Exhibit A:
Response to Comments Submitted by RW Harden and Associates (RHW&A)
Prepared by: GMA 12 Consultants

INTERA, Inc., D. B. Stephens & Associates, and Ground Water Consultants, LLC. 2020. GMA 12 Update to the Groundwater Availability Model for the Central Portion of the Sparta, Queen City, and Carrizo-Wilcox Aquifers: Update to Improve the Representation of the Transmissivity Properties of the Simsboro Aquifer in the Vicinity of the Vista Ridge Well Field, Prepared for the Groundwater Management Area 12. October 2020

Cooper-Jacob Straight-Line Analysis for Determining Transmissivity Values from the 36-hour Pumping Test Data from PW-11 and PW-16

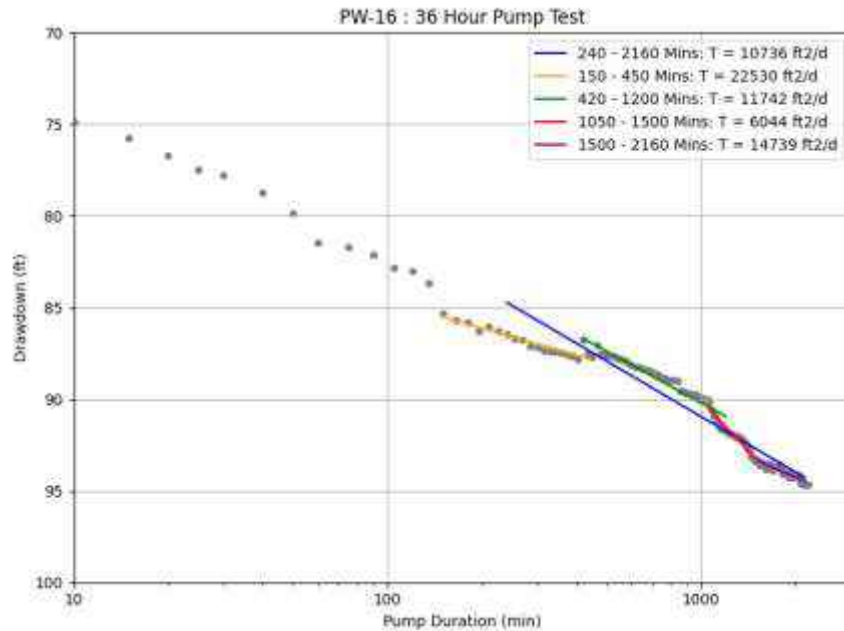
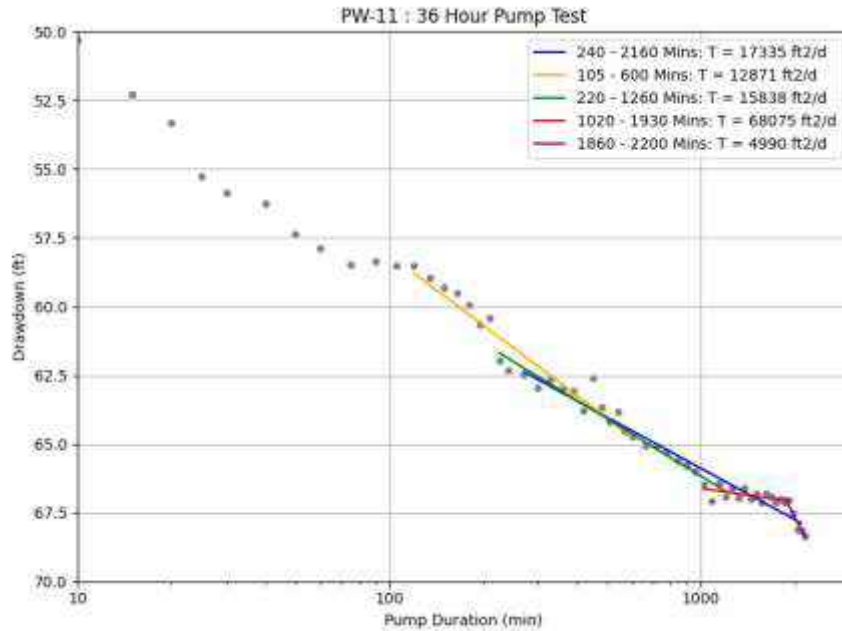
4. In order to illustrate that the spatial variability in the Simsboro transmissivity field is underestimated by using only the nine transmissivity values calculated from the nine aquifer

tests, INTERA has generated Attachment B. Attachment B shows results from applying the CJSI method over time periods of greater than 5 hours to the pumping tests for PW-11 and PW-16, using the same method used to analyze the 36-hour pumping tests in the GAM report. The analysis in Appendix B shows:

- For PW-11, the drawdown data was divided into four periods of between 5 and 19 hours for which CJSI transmissivity values were calculated. These four transmissivity values are: 12,871 ft²/day, 15,838 ft²/day, 28,075 ft²/day, and 4,900 ft²/day.
- For PW-16, the drawdown data was divided into four periods of between 5 and 13 hours for which CJSI transmissivity values were calculated. These four transmissivity values are: 22,500 ft²/day, 11,742 ft²/day, 6,044, and 4,900 ft²/day.

By parsing the aquifer test data into time periods of 5 hours and greater, we are able to find evidence of smaller scale variability in the transmissivity field than is possible by looking only at the transmissivity values calculated over 36-hour periods. The analysis of calculating transmissivity values over time scales less than 36 hours produces a range of transmissivity values for both wells that range from less than 60% to more than 50% of their reported values in Table 1.

Figure 3 Simsboro Transmissivity Field in the GAM (Young and others, 2018)

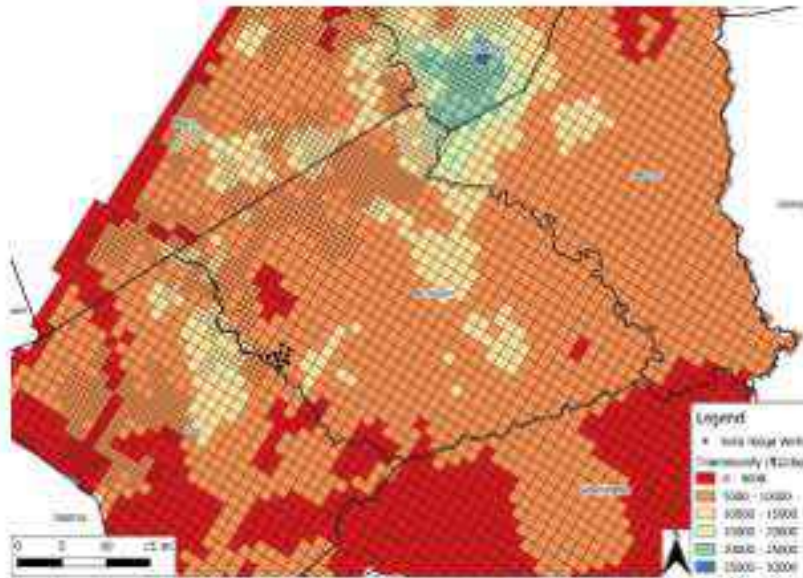
Comment #2. Simsboro (Layer 9) Transmissivity Artifact. There appears to be a modeling/interpolation artifact in the modified Simsboro transmissivity field encompassing the Vista Ridge well field area. As shown in Figure 1, there is a distinct, box-shaped transition zone between the modified and unmodified cells that is not consistent with the recorded, regional distribution of hydraulic parameters in the Simsboro. For example, the transmissivity of modified model cells near the eastern transition zone ranges from approximately 5,700 to 19,600 ft²/day, while nearby unmodified model cells are much less transmissive, with maximum assigned values ranging up to about 9,400 ft²/day. The apparent artifact correlates to the orientation of the pilot point array applied to PEST as shown in Figure 2 of INTERA's October 2020 report. This box-shaped transition suggests that the parameter estimation results and the methods by which those values were integrated into the original transmissivity field should be re-analyzed and possibly corrected.

One important point associated with the modified transmissivity values is that they were generated by PEST for a very different set of model calibration criteria than used by PEST to generate the unmodified transmissivity values. Thus, the magnitude and spatial variation in the modified transmissivity values should be different than for the unmodified transmissivity values. The second important point is that along the outermost column or row where the transmissivity values were modified, the average change is less than 25% difference along three out of the four sides. A difference of less than 25% is a relatively small amount given that differences in

transmissivity much larger than 25% occur across a mile distance in many regions of the unmodified transmissivity field such as in Robertson County (Attachment A, Figure 3) and among transmissivities that were calculated among the Vista Ridge Simsboro Aquifer screened wells. A third important observation is that, it appears that a similar box could have been drawn around the high transmissivity values in Robertson County in the unmodified GAM (see Attachment C, Figure 3) to encompass elevated transmissivity values associated with the City of Bryan/College Station well field.

Figure 4 Simsboro Transmissivity Field in the Modified GAM. Line A-A' marks the location between the modified and unmodified Simsboro transmissivity values along in the down dip of the Vista Ridge well field.

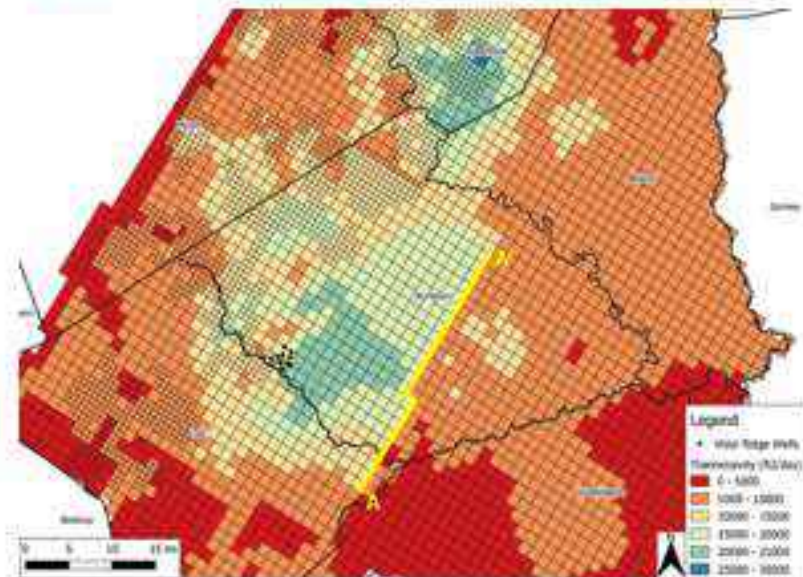
Comment #2 High Simsboro (Layer 9) Transmissivity. The recently modified and proposed model parameters assigned to areas adjacent to the Vista Ridge well field significantly exceed measured transmissivity values calculated within the Vista Ridge well field. Figure 1 below is a contour plot of the modified Simsboro transmissivity values from the GAM in the GMA-12 region. As shown, there are model nodes/cells adjacent to (east of) the Vista Ridge well field exhibiting transmissivities greater than 24,800 feet square per day (ft^2/day) (184,800 gallons per day per foot [$\text{gal}/\text{day}/\text{ft}$]). The pumping test data provided by Vista Ridge revealed that the greatest transmissivity value derived from short-term (36-hour) Simsboro aquifer testing is approximately 18,300 ft^2/day (137,000 $\text{gal}/\text{day}/\text{ft}$), while the longer-term (28-day) testing of PW-13 indicates a transmissivity value of approximately 15,200 ft^2/day (114,000 $\text{gal}/\text{day}/\text{ft}$).

Within the area contained inside the box identified by the RWH&A, the transmissivity values were increased by an average multiplier of 1.7, or 70% with the smallest and greatest changes in the updip (Northwest) and downdip (Southeast) portions of the box, respectively. Unlike up dip portions of the box, where the transition between modified and unmodified transmissivity values are difficult to distinguish, across the down dip portion of the box the transition between unmodified and modified transmissivity values is distinguishable. This boundary is marked by the line A-A' in Figure 4 in Attachment C. The modified transmissivity values are about twice the values of the unmodified transmissivity value. To explain this increase, we have modified Section 3 of the report to include the following discussion.

“As part of the recalibration of the GAM, several attempts were made to reduce the amount of increase in the Simsboro transmissivity values in the vicinity of line A-A' shown in Attachment C. These investigations showed that notable reductions in transmissivity values in the vicinity of line A - A' adversely affected the match between the calculated transmissivity values from the aquifer pumping test and the GAM simulation. Based on these results, we deduced that the Simsboro transmissivity values in the unmodified GAM and in the vicinity of Line A-A' and down-dip of Line A-A' were likely a result of a combination of too great of a trend of decrease in hydraulic conductivity with depth that was built into the GAM (Young and others, 2018) and a possible underestimation of net sand thickness down dip of Line A-A'.

We did not pursue additional studies to adjust Simsboro transmissivity values down in the vicinity and downdip of Line A-A' for several reasons. One reason is that the additional studies is beyond the scope of GMA 12 directive to modify the GAM by adjusting the hydraulic conductivity values of the Simsboro Aquifer in the vicinity of the Vista Ridge well field. Another reason is that the pursuit of additional studies would likely prevent the completion of the modified GAM for use by GMA 12 for the current planning cycle. In addition, the GMA 12 consultants are unsure if there is sufficient hydrogeological data to properly guide the changes in the Simsboro transmissivity field down dip of Line A-A' at this time.
